ERRATA And ADDENDA SHEET

APPLICABLE TO
 PUBLICATION NO. NEDO-21159
 TITLE Airborne Releases from
BWR's for Environmental
Impact Evaluations
 ISSUE DATE March 1976

NO. 1
 DATE April 13, 1976
NOTE *Correct all copies of the applicable publication as specified below.*

Figure 3-19. Monticello Station Releases Rates of I-131 (AEC/EPA Measurements)

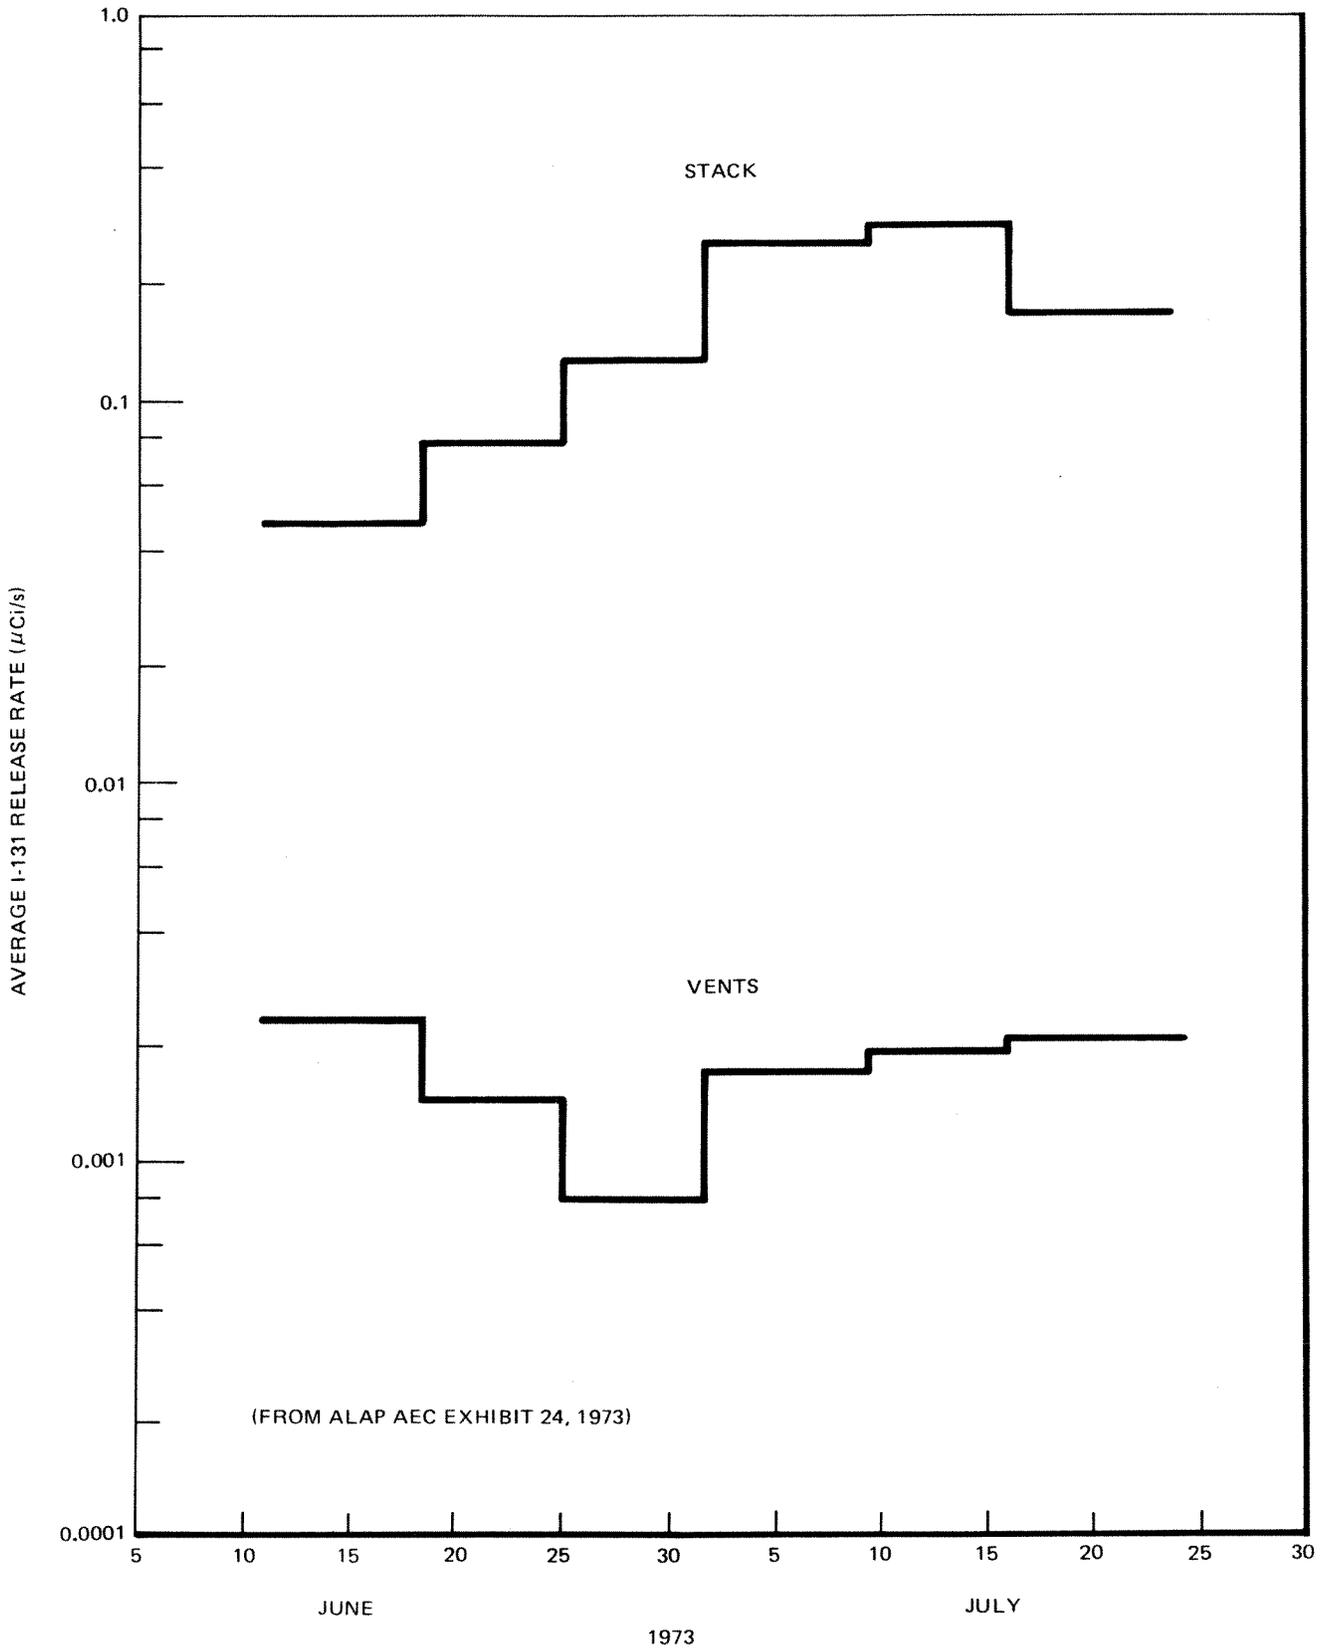
6.	Pages 3-45 and 3-46	Insert attached Figures 3-19 and 3-20.
7.	Page 7-4, Table 7-2	The last item in the column headed Weighting Factor should read (Reactor and Turbine = 0).
